Comments of Public Service Company of New Hampshire
on
EPA's Revised Draft National Pollutant Discharge Elimination System
Permit No. NH 0001465
for
Merrimack Station

**Public Service
of New Hampshire**

Submitted to the U.S. Environmental Protection Agency

August 18, 2014

Figure 4-4
Monfalcone Power Station - FGD Treatment System Flow Schematic

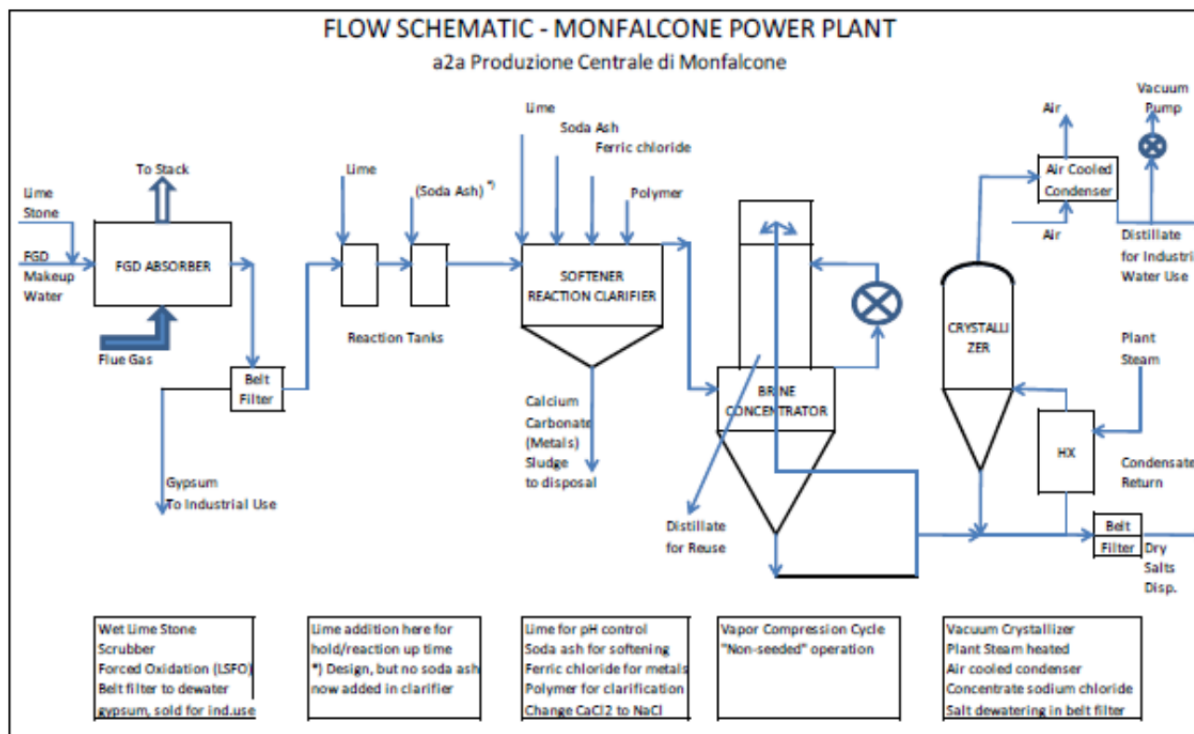
A block flow diagram for the system (from the facility's permit), plainly shows a discharge from the system (labeled "Distillate for Industrial Water Use").

Thus, the system does not achieve complete ZLD.
